# Technical Memorandum

Re: Preliminary Hydrogeological Assessment  
Proposed Residential Development - Bonarrow Meadows  
Rockwood, Township of Guelph-Eramosa

**Table 1: Agency and Public Comments and Responses**

Map 7-48: Rockwood Water Supply Wellhead Protection Area Initial Vulnerability (Insert)

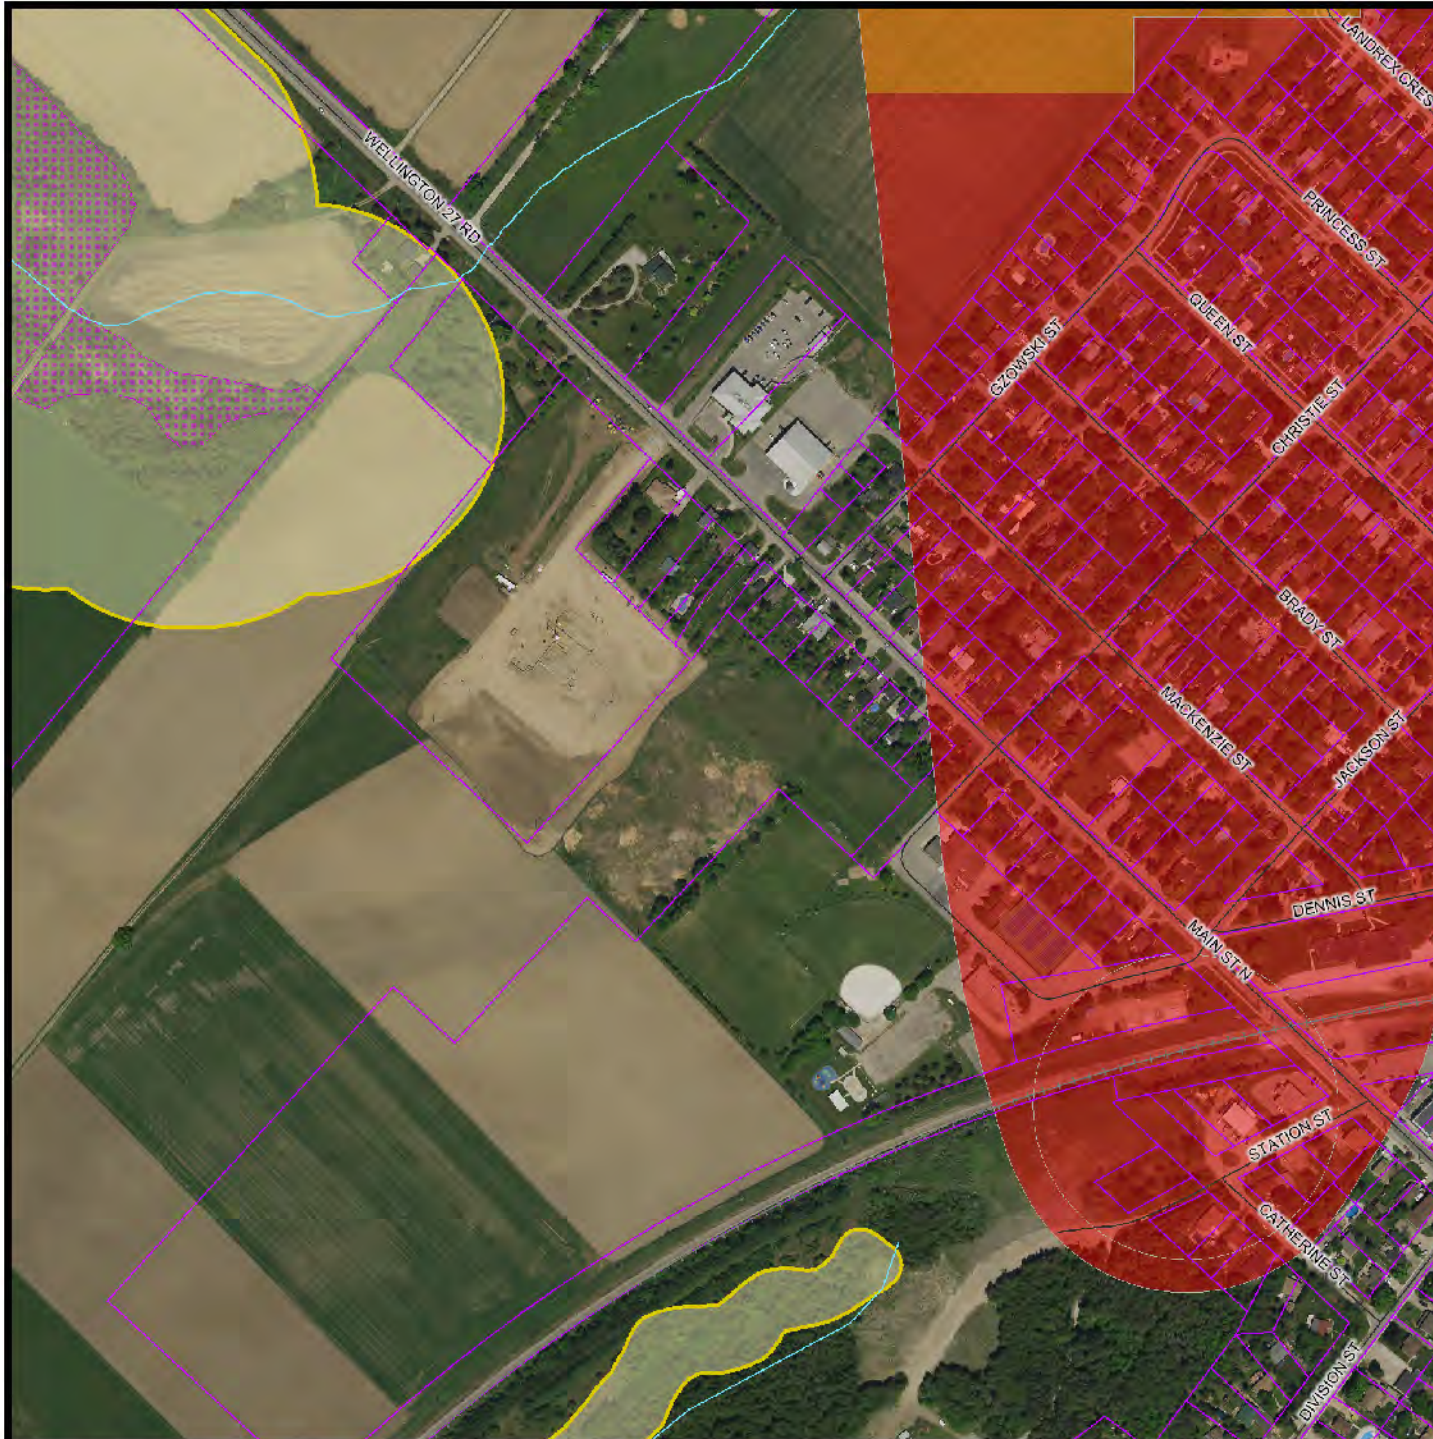
1.14	<p>Mapping should be revised to show the site on same map as the local WHPA and IPZ.</p>	<p>There are no Intake Protection Zones included in the 2012 Approved Assessment Report associated with the Station Street Rockwood Wells 1 and 2.</p> <p>The WHPA is shown relative to the site on an additional appended map.</p>	5  Map Appended

1.	<p><b>Kyle Davis, Risk Management Official, Wellington Source Water Protection</b></p> <p>The proposed subdivision is not located within the approved Wellhead Protection Areas (WHPA) for Rockwood although the corner of the property abuts the WHPA - B (two year time of travel, vulnerability score 10) at Christie Street. Please see the attached map for further detail.</p> <p>Therefore no Grand River Source Protection Plan, significant threat policies currently apply to the property.</p>	<p>Acknowledged. The WHPA is shown relative to the site on an additional appended map.</p>	Map Appended
